CITY OF ALBUQUERQUE

RE: Lot 50 Block 6 Volcano Cliffs Unit 18 SAD 228 6209 Canavio Pl. NW
Grading and Drainage Plan
Engineers Stamp Date 10/1/2018 (D10D003V50)
Pad Certification Date 3/2/2021

Based upon the information provided in your submittal received 3/3/2021, this plan is approved for Building Permit.

ENGINEER'S SEAL GRADING AND DRAINAGE PLAN 10/1/18 DAVID SOULE P.E. #14522

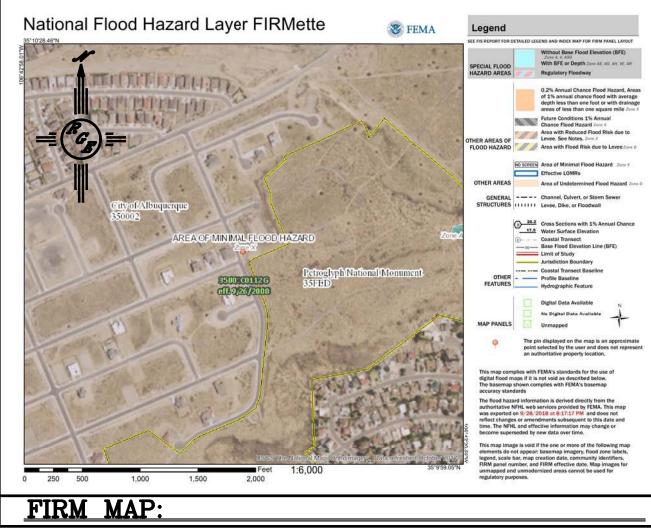
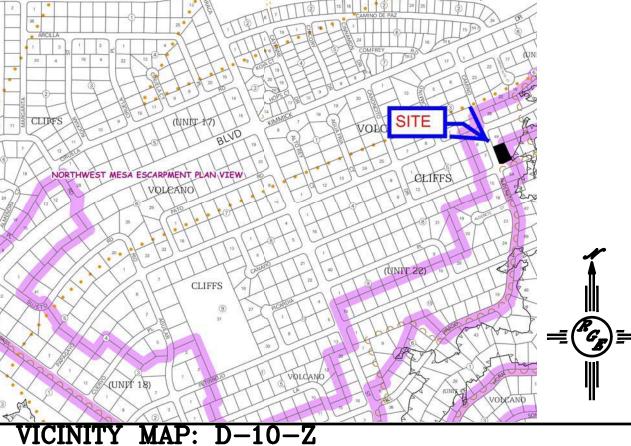
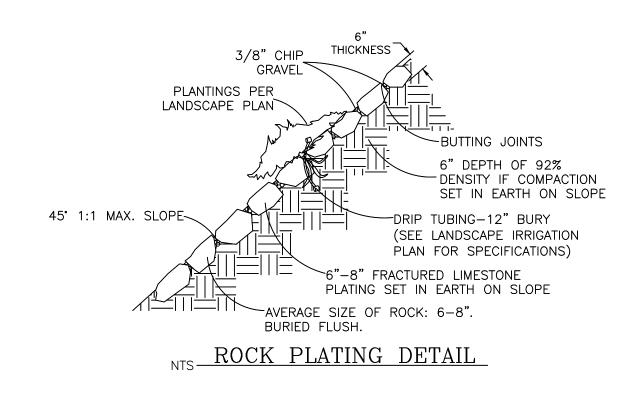
Reiterate to the Owner/Contractor that a separate permit for a garden/retaining wall must be obtained, with the approved G&D plan and Pad Certification. Also, let the owner/contractor know that if a pool is to be added in the future the G&D plan will need to be modified showing the location of the pool and the land treatment differences.

Prior to Certificate of Occupancy release, Engineer Certification per the DPM checklist of this plan will be required.
